V2500-A5/D5 SERIES PROPULSION SYSTEM SERVICE BULLETIN

This document transmits Revision 1 to Service Bulletin EV2500-73-0191 and Revision 1 to the Supplement

V2500-ENG-73-0191
Transmittal - Page 1 of 2

ENGINE FUEL AND CONTROL – FUEL METERING UNIT – INTRODUCTION OF REVISED DYNAMIC SEALS
AND VALVE PUSHRODS

V2522-A5 and V2524-A5 FMU Family Tree
Chart 1 (sheet 1 of 2)

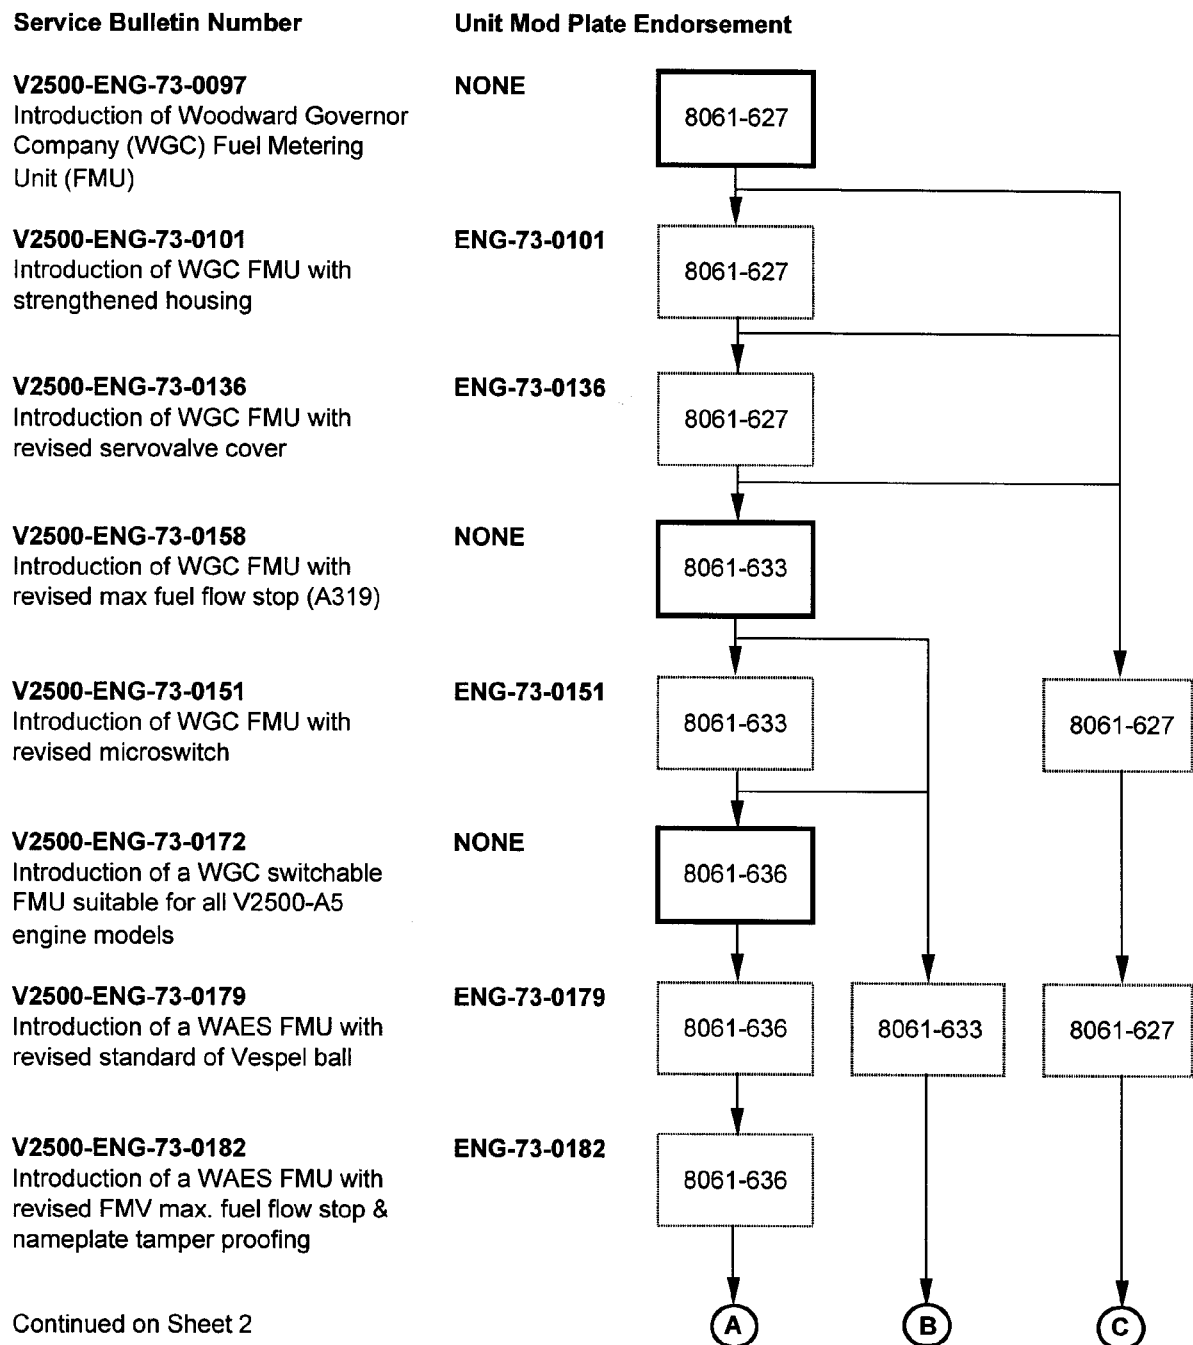
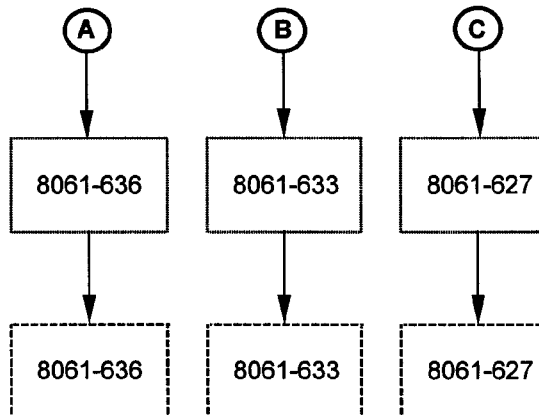
Introduction of a WAES FMU with revised dynamic seals and valve pushrods

V2527-A5 and V2527E-A5 FMU Family Tree
Chart 2 (sheet 1 of 2)

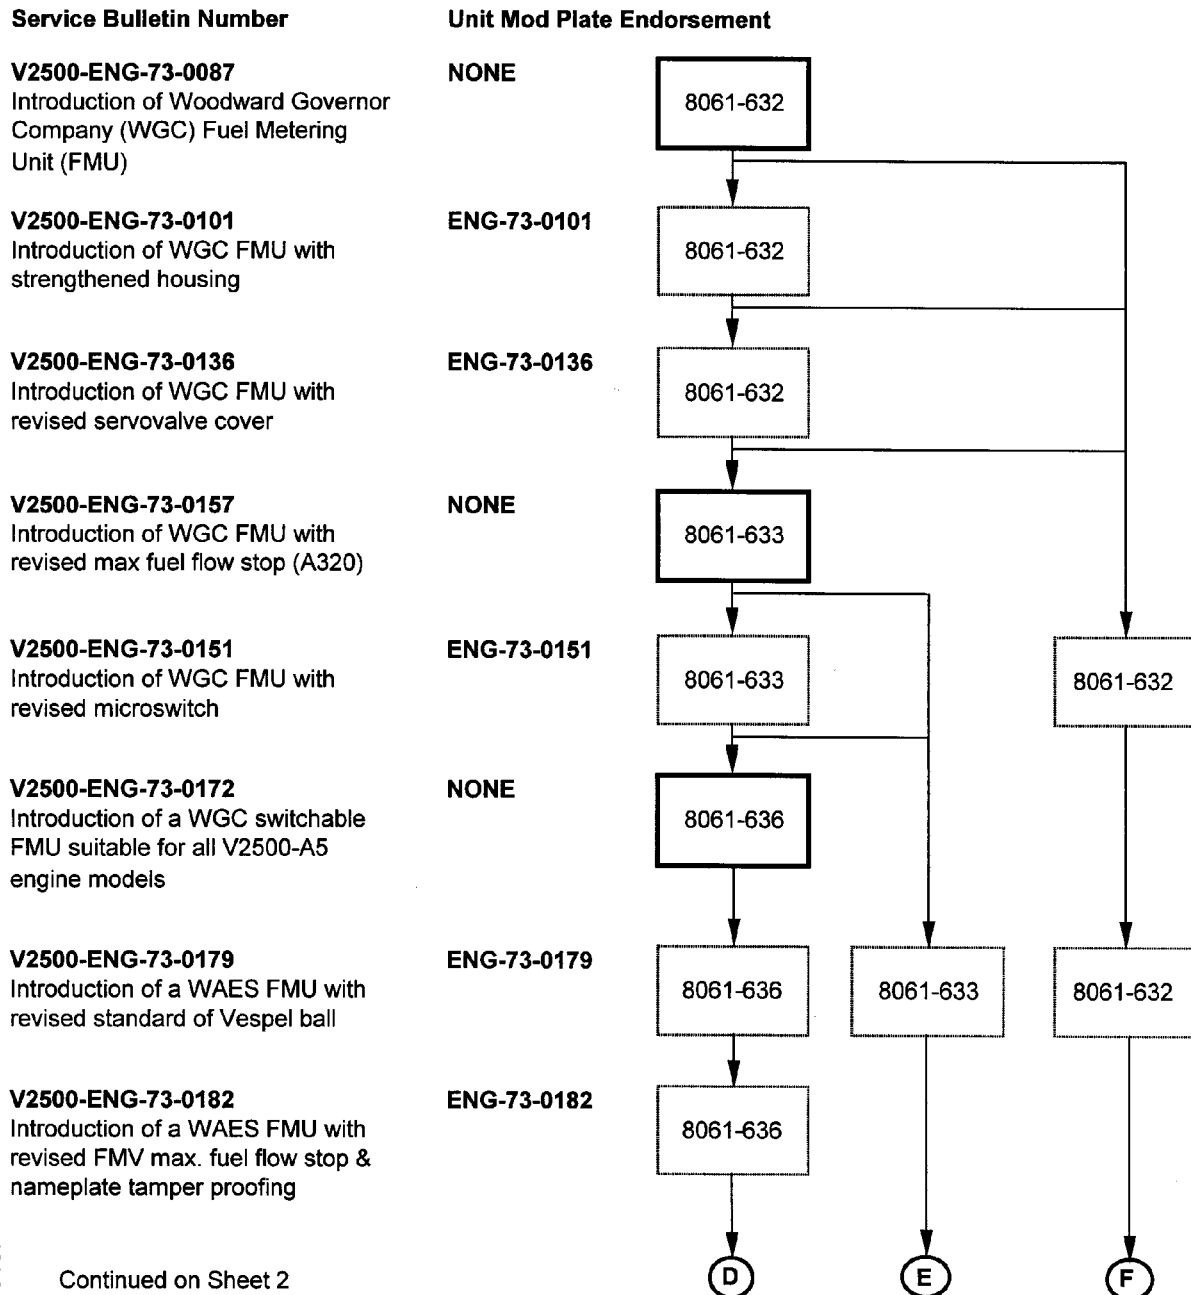
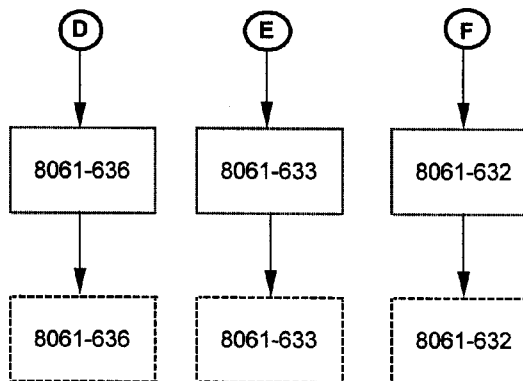
Introduction of a WAES FMU with revised dynamic seals and valve pushrods

V2530-A5 and V2533-A5 FMU Family Tree
Chart 4 (sheet 2 of 2)

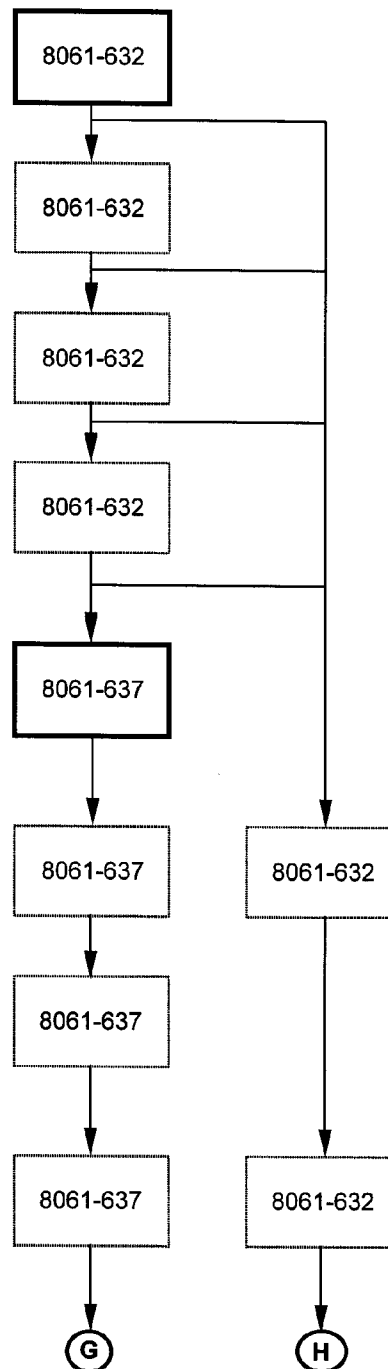
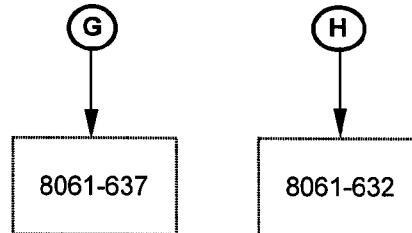
Introduction of a WAES FMU with
revised dynamic seals and valve
pushrods

V2525-D5 and V2528-D5 FMU Family Tree
Chart 5 (sheet 1 of 1)

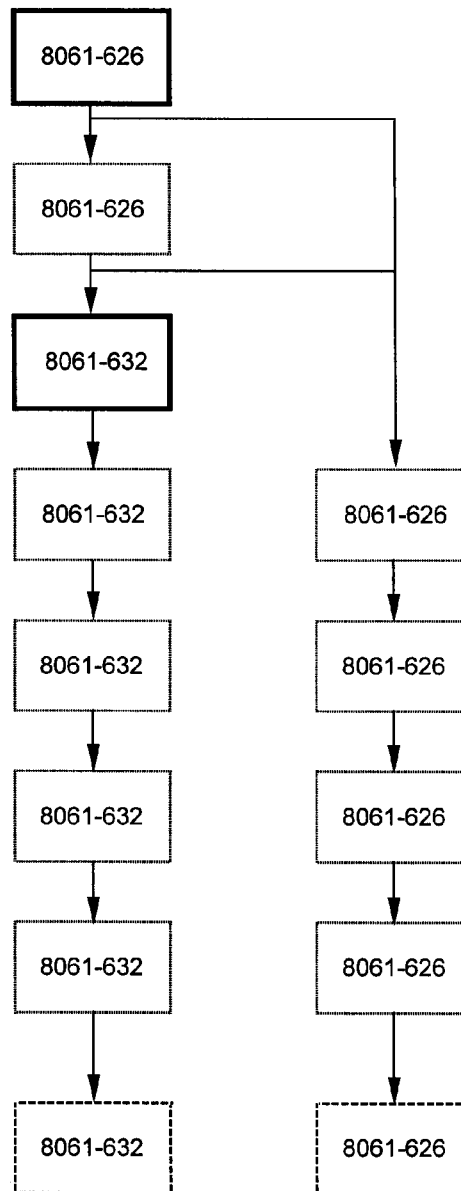
Inroduction of a WAES FMU with revised dynamic seals and valve pushrods
